Origination Form
Proposed Revisions to a Standard Plans Index

Originator:	Turley, Joshua	Index Number:	102-201
Date:	6/17/2025	Sheet Number(s):	1-5
E-mail:	Joshua.Turley@dot.state.fl.us	Index Title:	Temporary Acrow 700XS Series Detour Bridge General Notes and Details

TEMPORARY ACROW 700XS SERIES DETOUR BRIDGE
GENERAL NOTE AND DETAILS

INDEX
102-201

SHEET
1 of 5

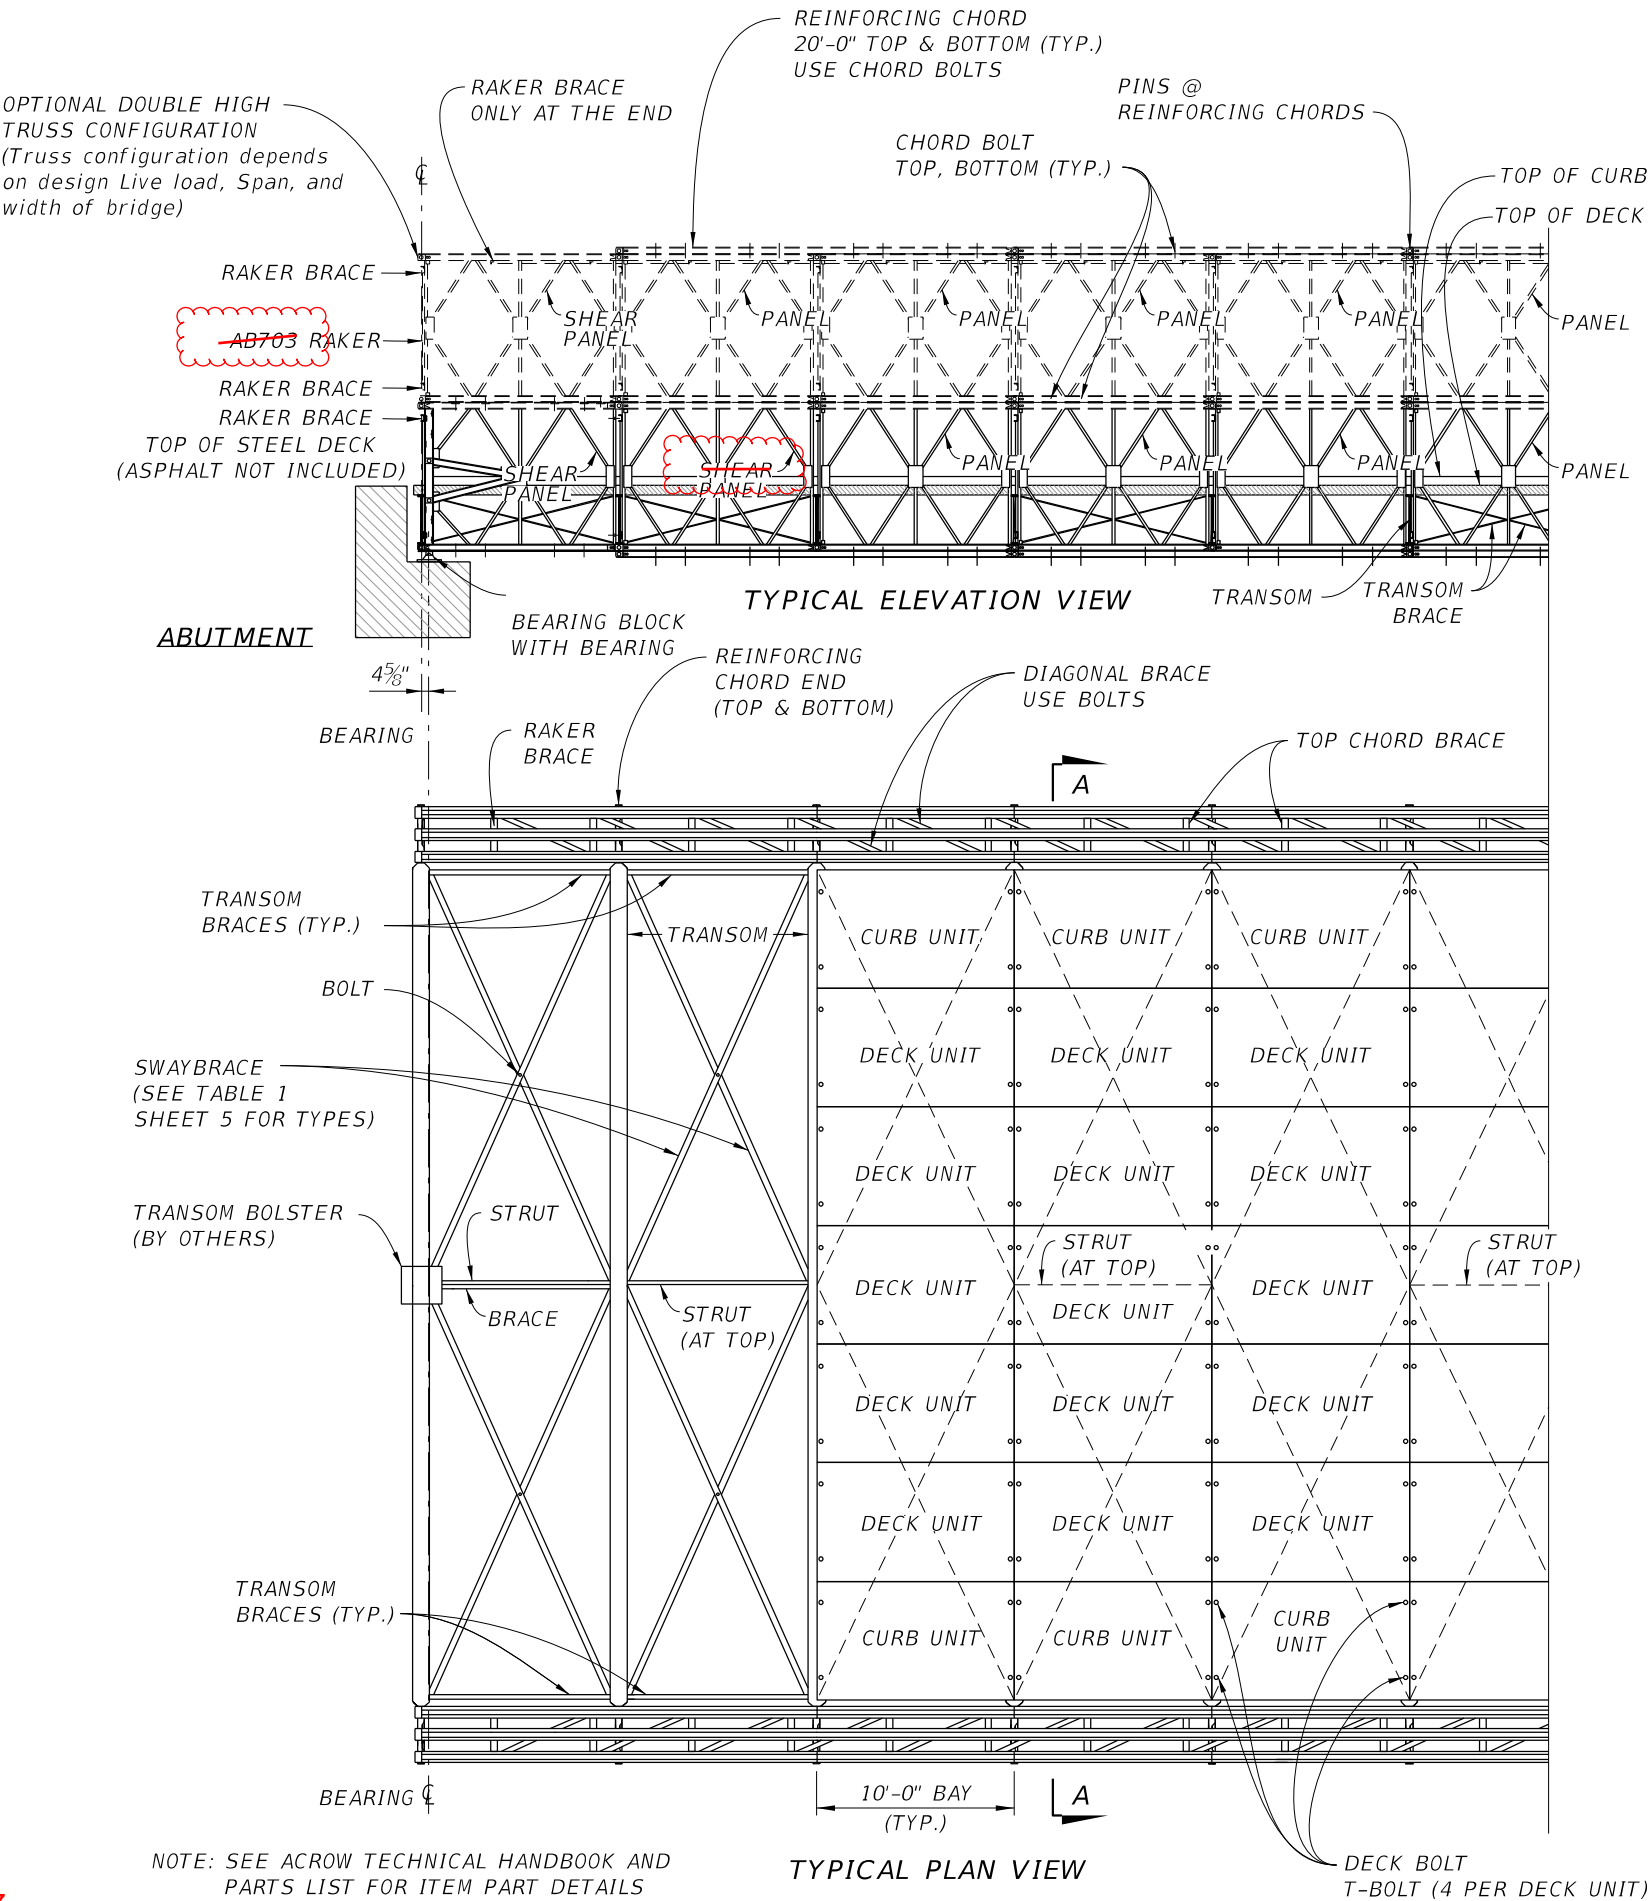
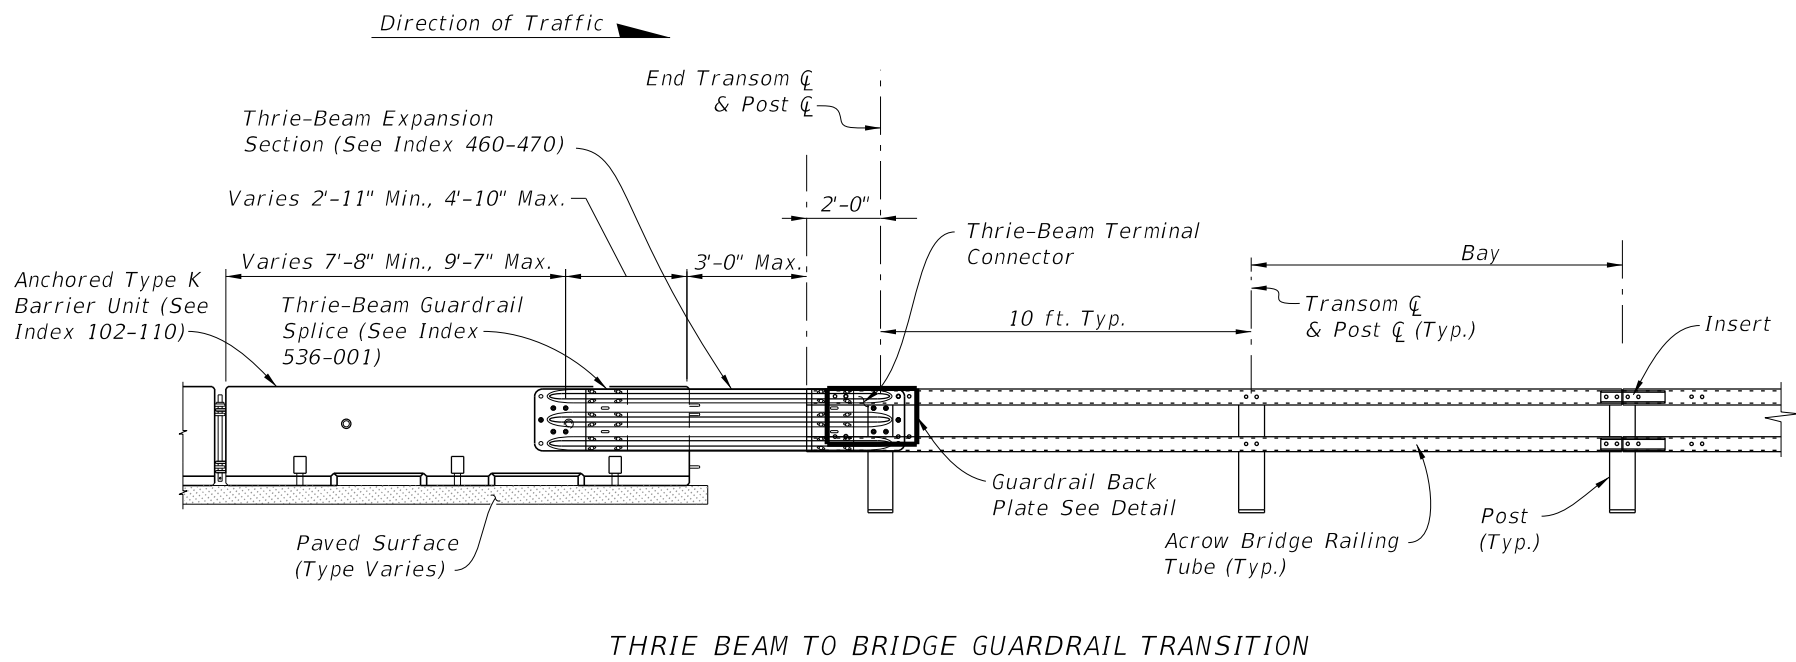
Sheet 1: Added some clarifying terms to the Notes. Removed errant shear panel and part number from TYPICAL ELEVATION VIEW.

except when deck and curb panels with an epoxy aggregate non-skid driving surface are used,

keeper channels

ends of the keeper channels

This Index is only applicable to the current FDOT inventory of temporary bridge components which are manufactured in accordance with Acrow Series 700XS three Lane 24',36', and 42' widths. Asphalt Overlay is required on the Bridge deck except when deck and curb panels with an epoxy aggregate non-skid driving surface are used, see Sheet 2 for details.

Distribution beam keeper channels restraining the distribution beams may be lengthened or shortened to center the distributing beam bearing on the cap beam. The ends of the keeper channels are to bear on the distributing beam end frame.

SECTION A-A
(Double High Truss shown, Single High Truss Similar)

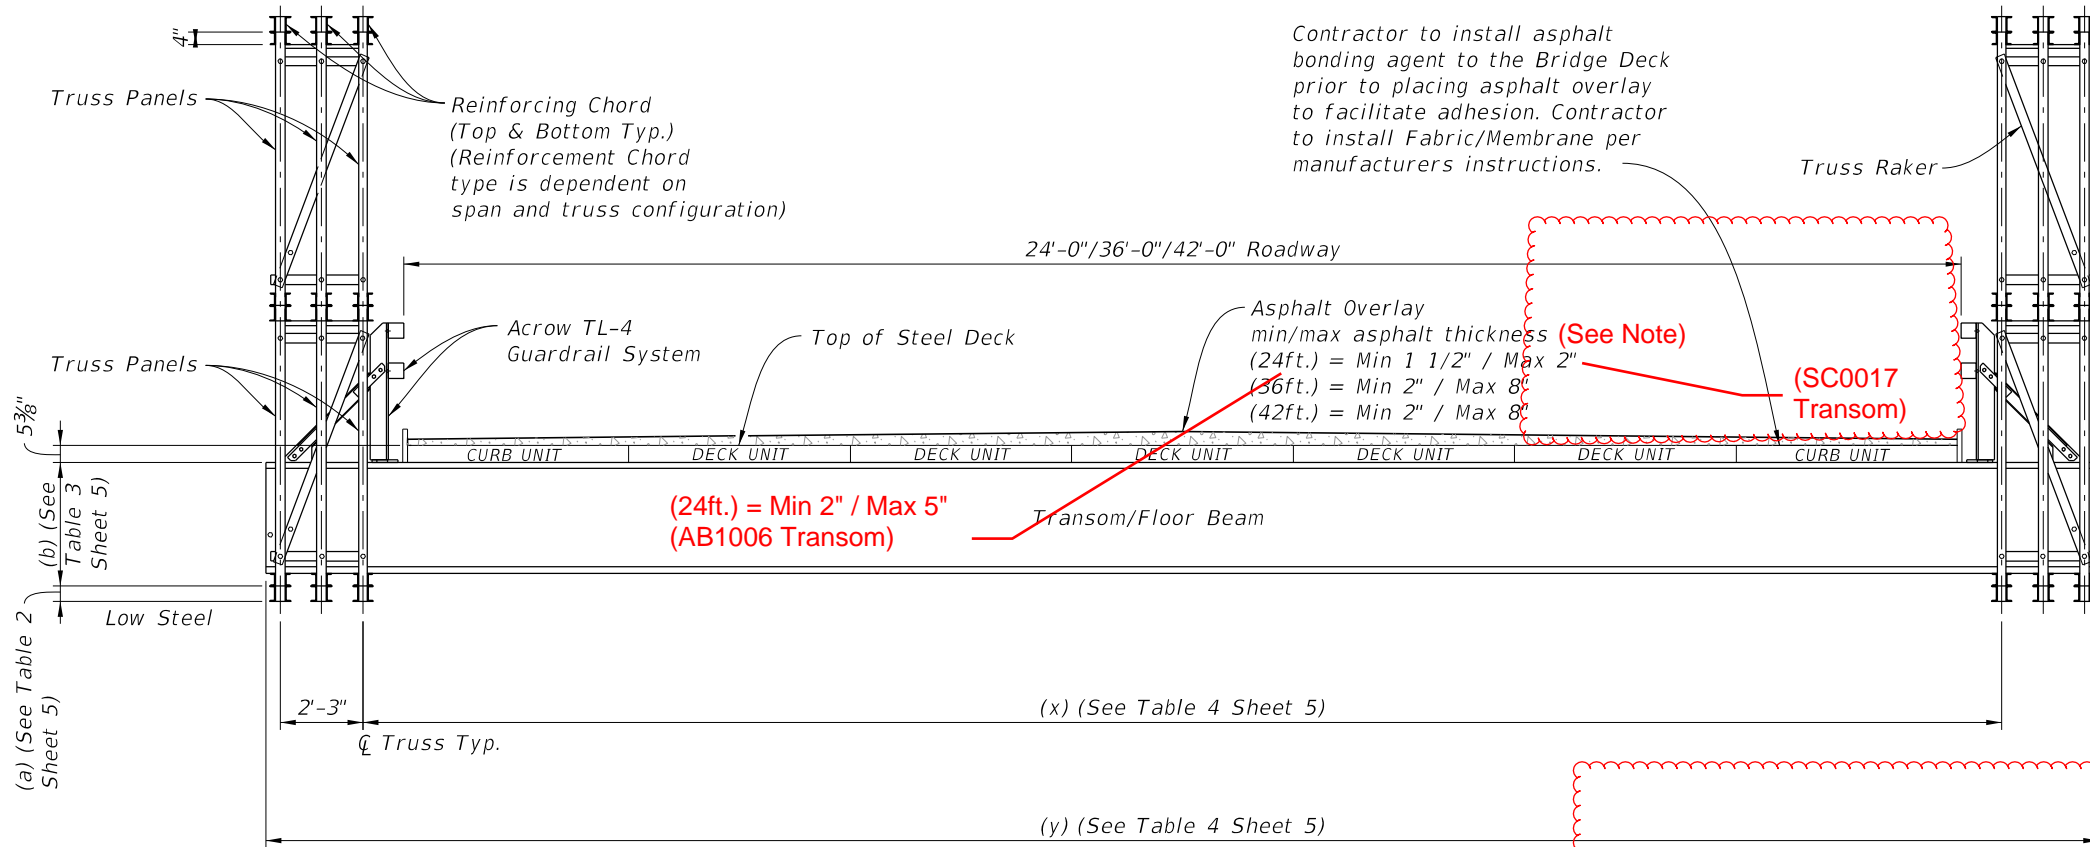
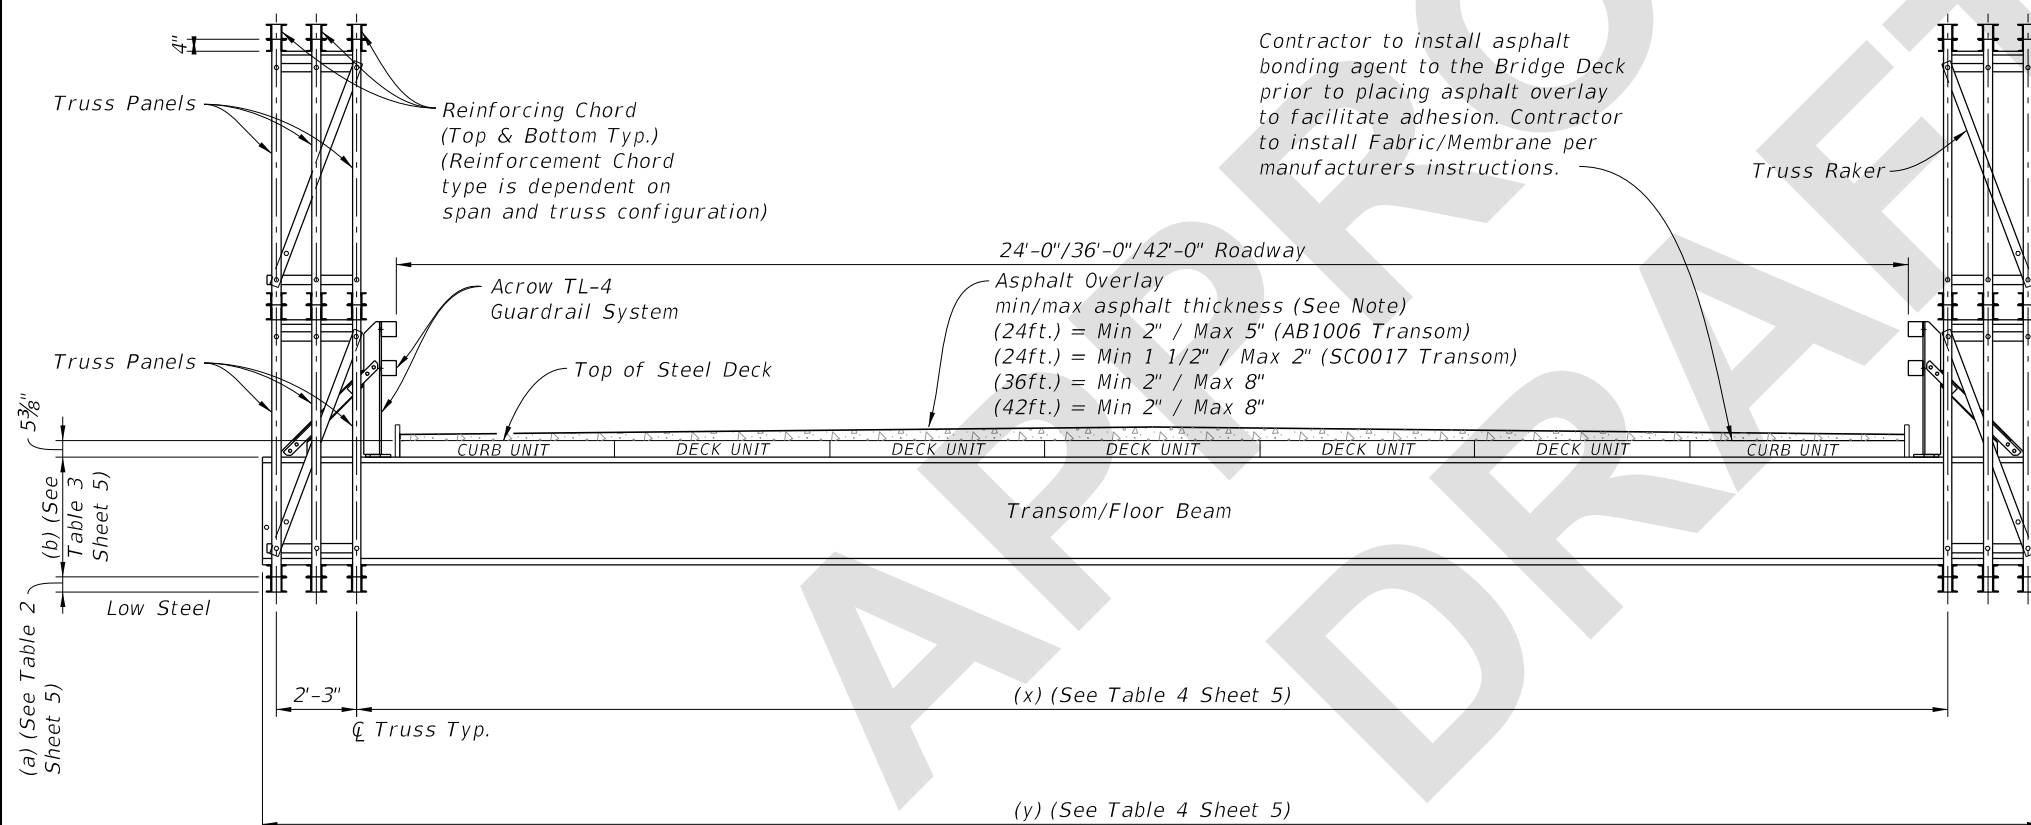
Sheet2: Added some clarifying language to asphalt overlay notes in SECTION A-A.

NOTES:

Asphalt overlay thickness shown is for when using plain steel deck.

NOTES: See Acrow Technical Handbook and parts list for item number details.
Asphalt overlay thickness shown is for when using plain steel deck.

TYPICAL DETAIL AT INTERMEDIATE PIER
(FOR CONTINUOUS SPAN DESIGN)

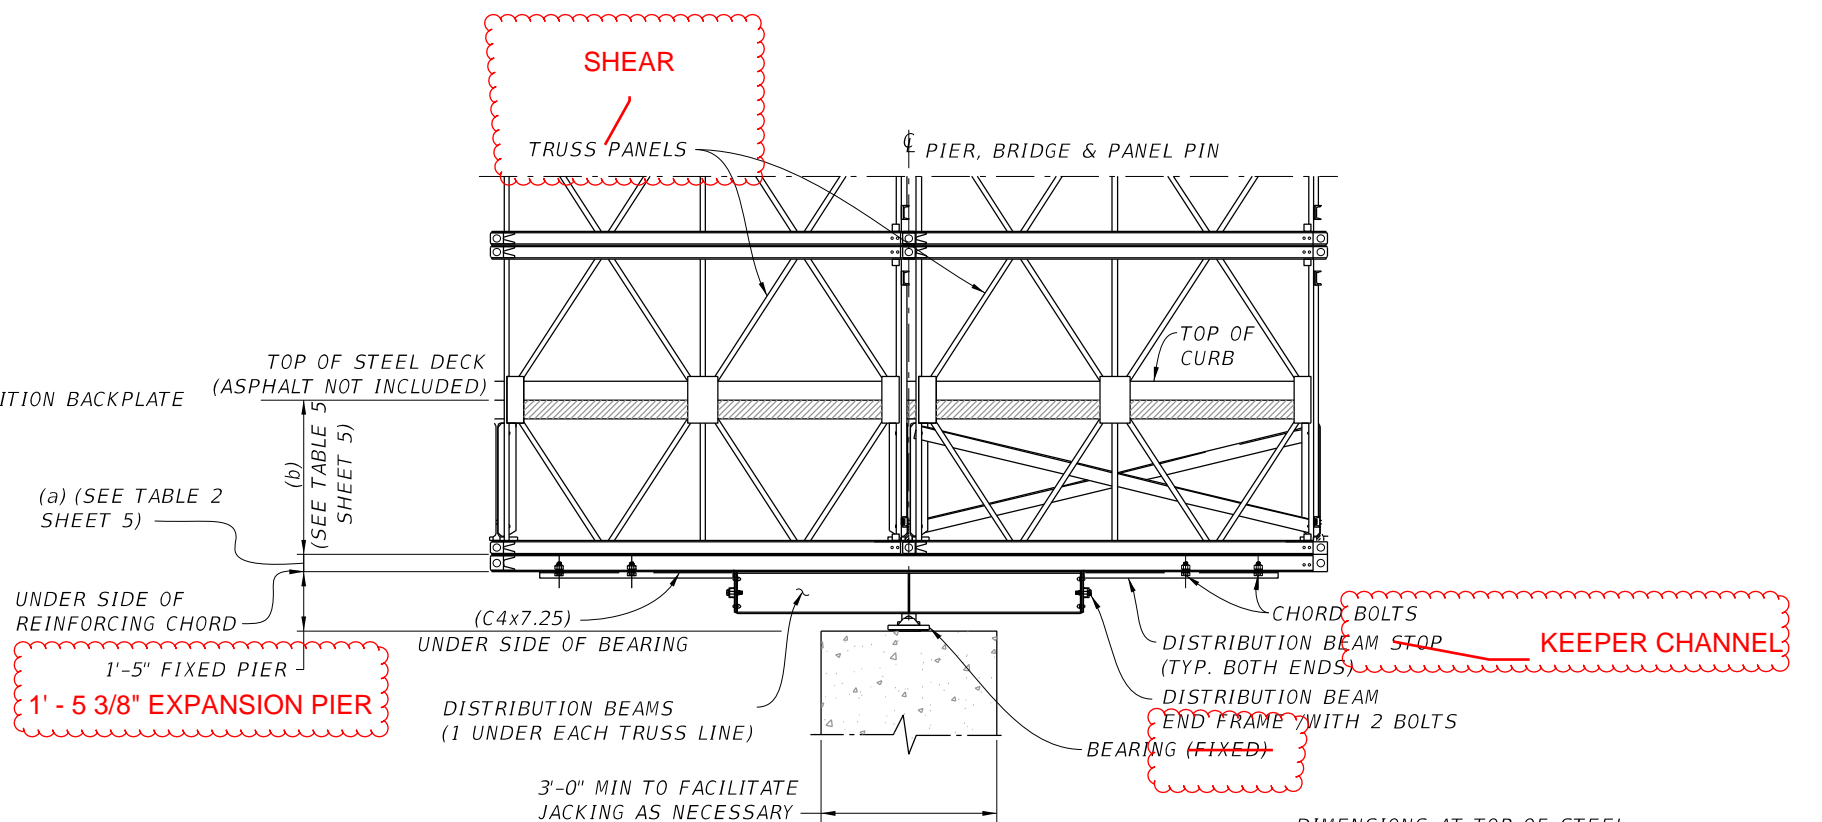
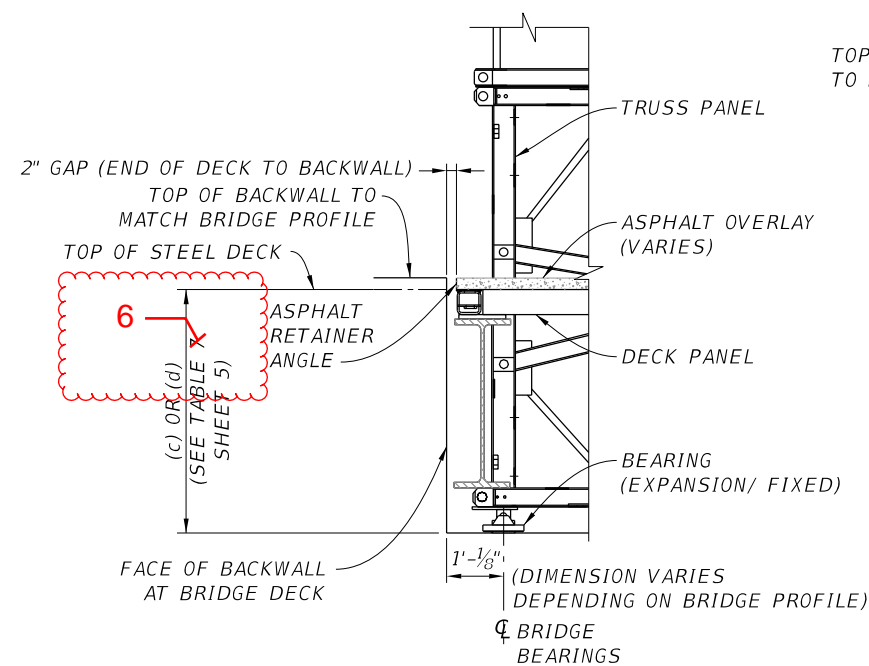
Sheet 3: Added clarifying notes to TYPICAL DETAIL AT INTERMEDIATE PIER. Corrected table reference in TYPICAL DETAIL AT ABUTMENTS. Added note to EOB AT DECK DETAIL
